**RE: Response to Comments on Landfill Area Groundwater Pre-Design Results Report,
W. R. Grace Superfund Site, Acton, Massachusetts**

This letter provides responses to the USEPA comments included in the June 9, 2009 letter RE: Conditional Approval of the Draft Landfill Area Groundwater Pre-Design Results Report, dated April 2009. No responses to the USEPA comments on Section 4 – Landfill Area Groundwater Modeling are provided in this letter because USEPA indicated that these comments do not need to be addressed at this time since it has been determined that the model alone will not be used as the sole basis for demonstrating appropriate capture.

TITLE: 2008 BENZENE PLUME WITH MODEL-CALCULATED CAPTURE ZONE AT EACH PUMPING WELL, MODEL LAYER 2

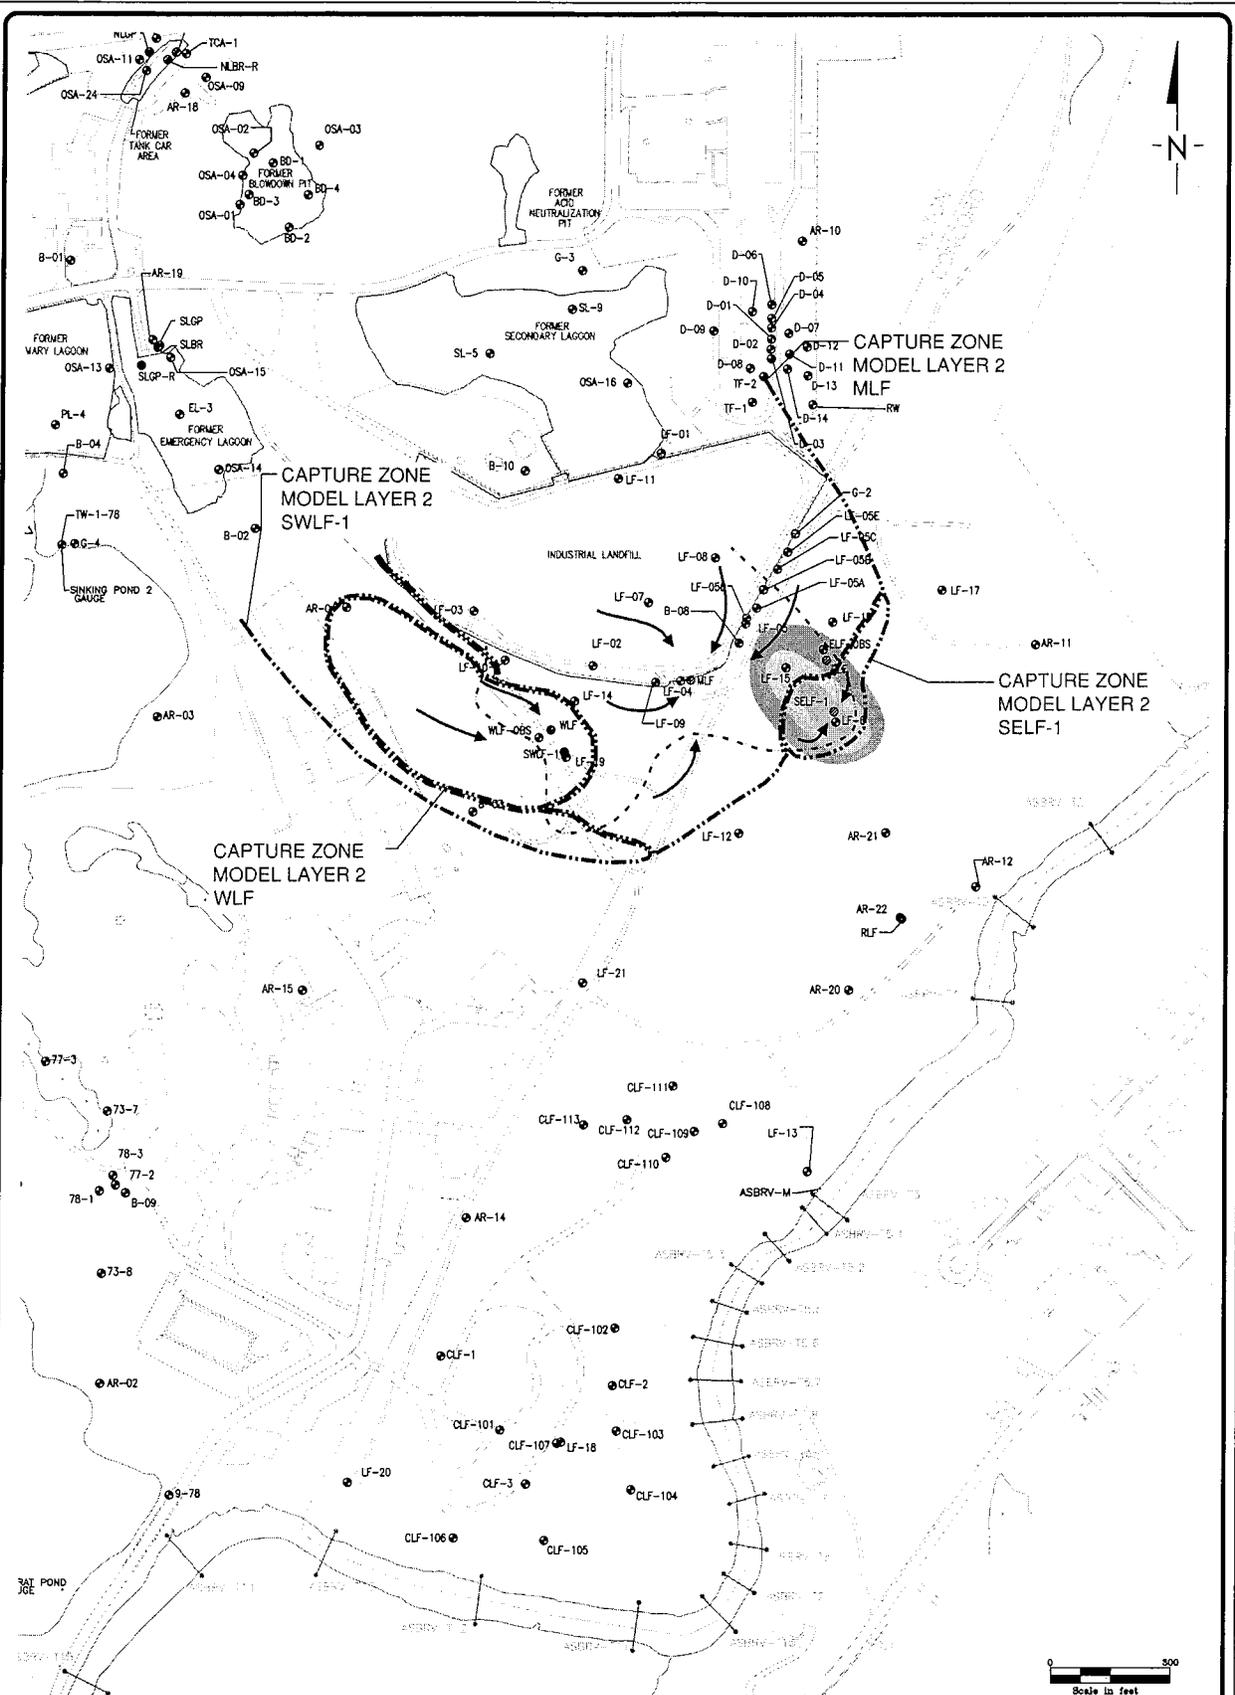
2. Page 4-7, Section 4.2 Landfill Area Capture Zone Evaluation, second paragraph. The particle tracking shown on Figures 4-7 through 4-10, while useful for envisioning the groundwater movement in the capture zone, would be complemented by figures showing the capture zones of the individual extraction wells in each model layer. Figures 3-2 through 3-6, in Appendix A of the Public Review Draft Remedial Investigation Report (GeoTrans, July 2005), are an example of the type of presentation that would be useful in understanding the flow dynamics. Please provide figures that show the individual extraction well capture zones in each layer, using figures similar to those presented in the RI report. The groundwater contour maps should include arrows and dashed lines depicting groundwater flow directions and extent of the capture zone. The maps should depict the ROD-required capture zone and the benzene and arsenic plumes, so that a simple comparison can be made between the current capture zone, the contamination mass, and the ROD-required capture zone.

***Response:** Figures 1 through 4, attached, show the model-calculated capture zones for each of the four Landfill Area groundwater extraction wells for model layers 2 through 5, respectively. Also shown on each of the figures is the ROD specified capture zone, arrows illustrating directions of groundwater flow and the benzene plume for model layers 2 through*

Figure 1 shows the four individual model layer 2 capture zones, that combined, make up the model-calculated Landfill Area capture zone that was depicted on Figures 4-7, 4-11, and 4-17 of the "Landfill Area Groundwater Pre-Design Results Report". Figure 1 shows that groundwater with the highest benzene concentrations in model layer 2, up to 1,800 µg/L, is located within the SELF-1 and MLF capture zones. Arrows illustrate the flow of groundwater within the WLF, MLF and SELF-1 capture zones toward each extraction well. Flow arrows are not depicted in the layer 2 capture zone for SWLF-1 because groundwater flow in that area would be downward through the till and into SWLF-1. Figure 2, which illustrates the individual capture zones and benzene plume for model layer 3, shows that benzene contamination is more widespread in model layer 3, but concentrations are significantly lower. The maximum benzene concentration detected in 2008 in a monitoring well completed in model layer 3 was 56 µg/L (see Figure 4-18 in the "Landfill Area Groundwater Pre-Design Results Report" for model layer 3 monitoring well concentrations). Figures 3 and 4, which illustrate the individual capture zones and benzene plumes for model layers 4 and 5, show that benzene contamination in model layers 4 and 5 is located further west, within the SWLF-1 and MLF capture zones. The maximum benzene concentration detected in 2008 in a monitoring well completed in model layer 4 or 5 was 61 µg/L (see Figure 4-19 and 4-20 in the "Landfill Area Groundwater Pre-Design Results Report" for model layer 4 and 5 monitoring well concentrations).
